Subject: Bechtel Comments on DG-1247

Attached for your consideration are comments on Draft Regulatory Guide DG-1247, "Design-Basis Hurricane and Hurricane Missiles for Nuclear Power Plants."

Comments on Draft Regulatory Guide DG-1247
Design-Basis Hurricane and Hurricane Missiles for Nuclear Power Plants

Figure 1f: Hurricane Carla (1961, colored contours from Ref. 8)

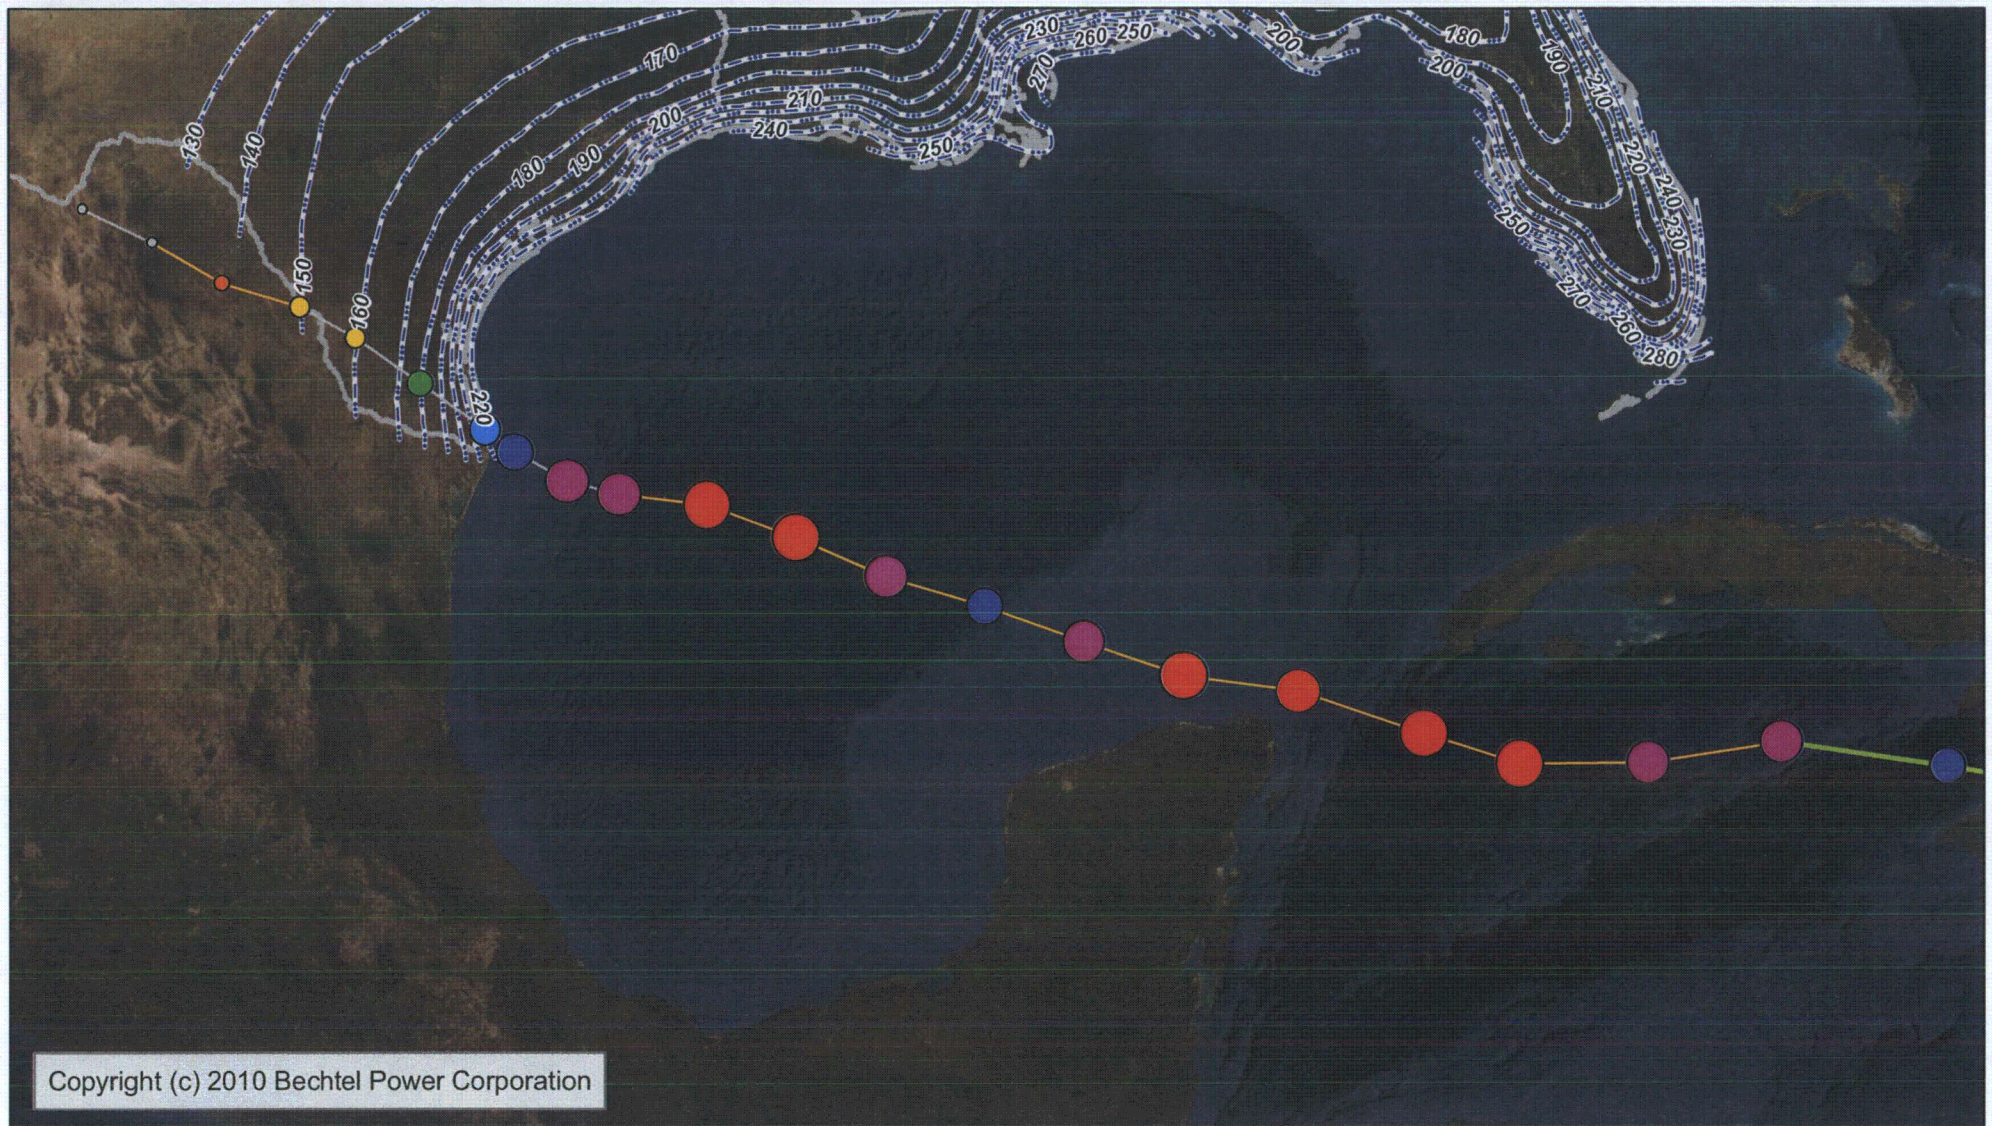
Texas						
Carla ('61)	4	144	176	220 (210)	+25% (+19%)	175 mph gust estimated at Port Lavaca, TX. Measured gust of 153 mph at Bauer Dredging Company (Port Lavaca, TX) before instrument failed. Figure 11 of MWR article (March 1962) has contour maps of max winds, see Figure 1f.
Allen ('80)	3	H: 127 L: 115 ⁷	H: 155 L: 141 ⁷	220 (210)	+43% (+35%) +56% (+49%)	Port Mansfield, TX observed 104 kt (120 mph) gust.
Alicia ('83)	2	115	141	220 (210)	+56% (+49%)	USCG cutter Buttonwood at east end of Galveston Island observed 43 ms ⁻¹ (96 mph) fastest mile speed with gusts of 56 ms ⁻¹ (125 mph). Figure 4 of MWR article contains contour maps of max winds.
Celia ('70)	3	127	155	220 (210)	+43% (+35%)	Nueces County (Corpus Christi), TX observed the following wind speeds: Lipan St CPL (Central Power and Light Company) 143 mph gust, NAS 120 mph gust, WSO 161 mph, Nueces Bay CPL 150+ mph. San Patricio, Co, TX observed the following: Gregory Reynolds Metal 128 mph fastest mile and 138 mph gust at 80 feet AGL, Odem 160 mph gust through eye, Mathis 150 mph gust.

Figure 2: Landfalling Category 3 and Higher Hurricanes in the Atlantic Basin

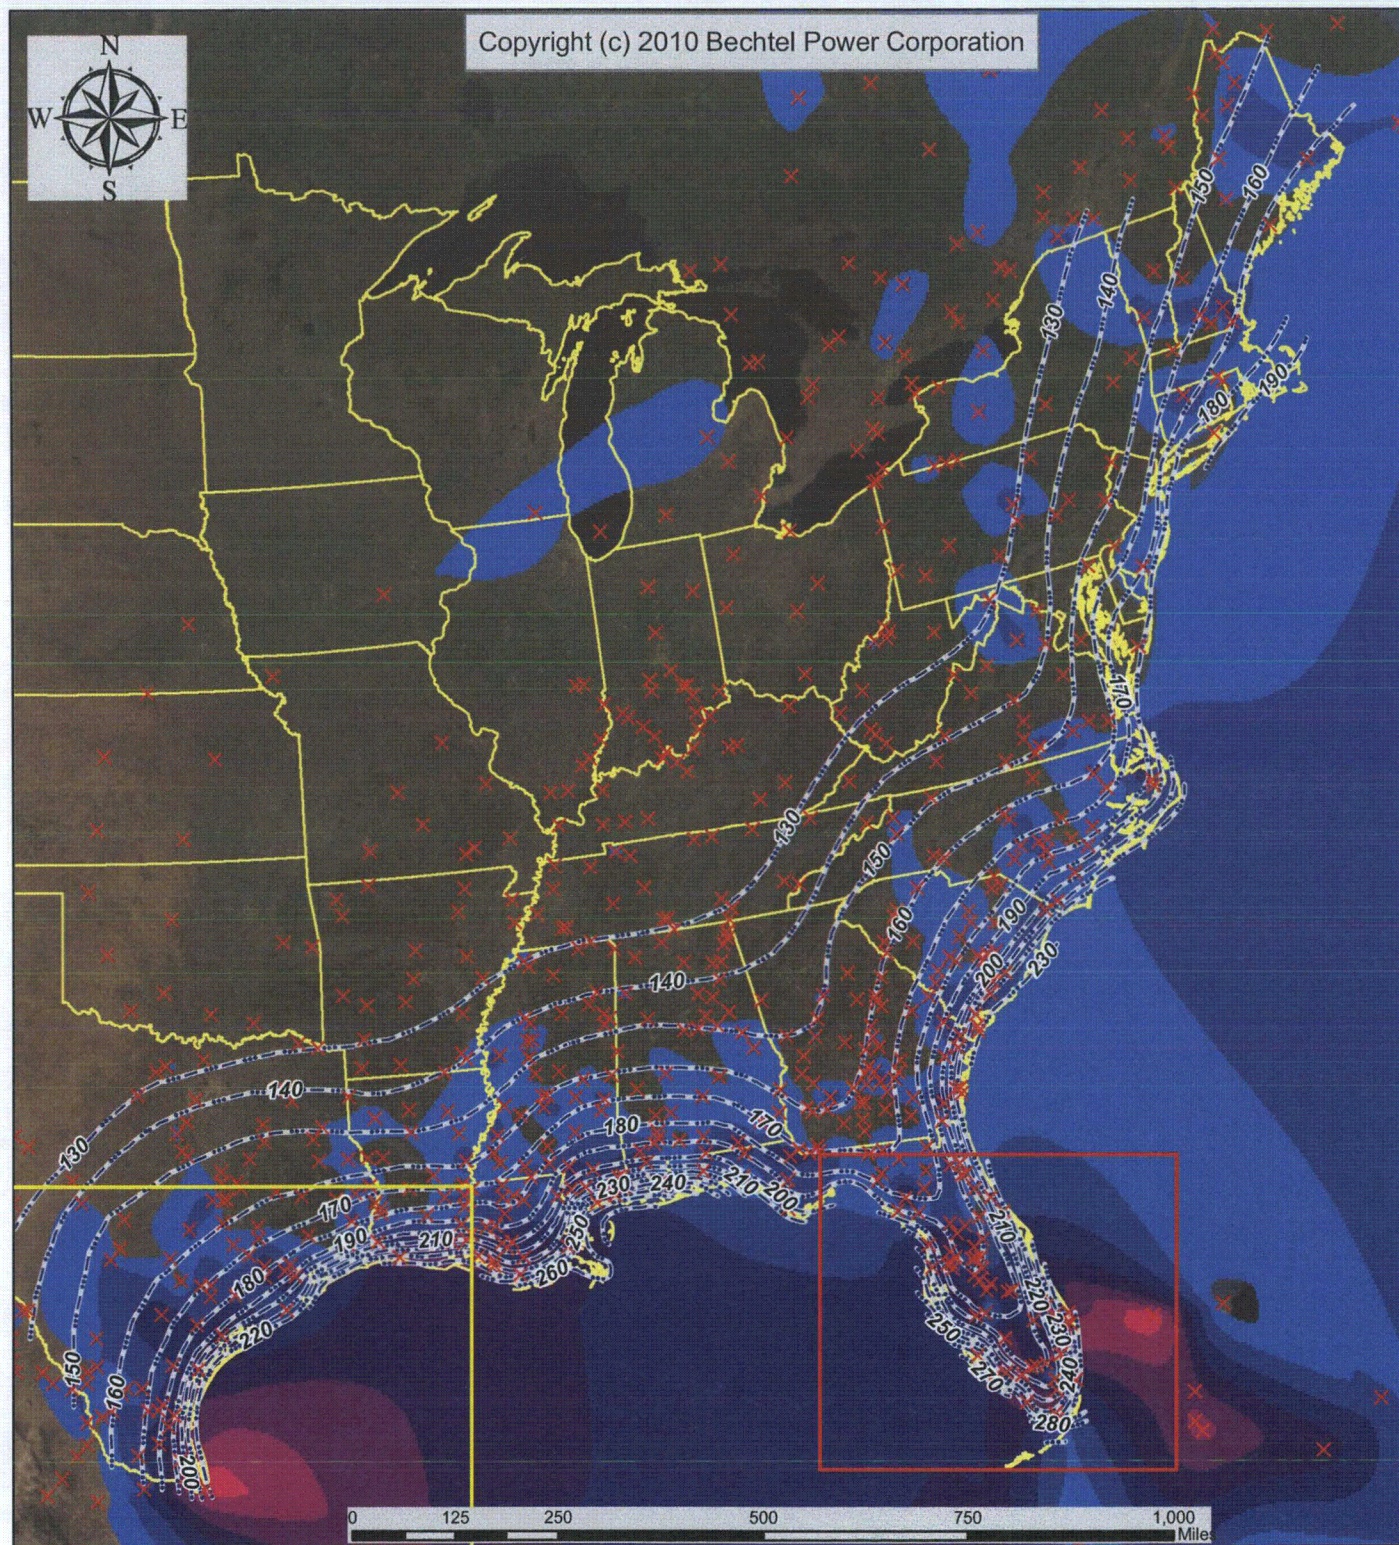
3. Related to items 1 and 2, for land-falling hurricanes in NUREG/CR-7005 (Reference 12) unrealistic translation wind speeds might have been used. For higher probability events, this limitation is not evident (see Figures 2-24 and 2-25 of Reference 12 or Figure 6-1 of Reference 5). At low frequency (10^{-6} or 10^{-7} per year), the wind speed values appear to have unrealistic behavior. Figure 2 shows contours of maximum estimated wind speeds from land-falling Category 3/4/5 hurricanes (Reference 1); these contours exhibit sharper gradients of wind speed than the contours from DG-1247. Using HURDAT data, Table 2 presents maximum landfall 3-second gust wind speed for Category 3 and above hurricanes.
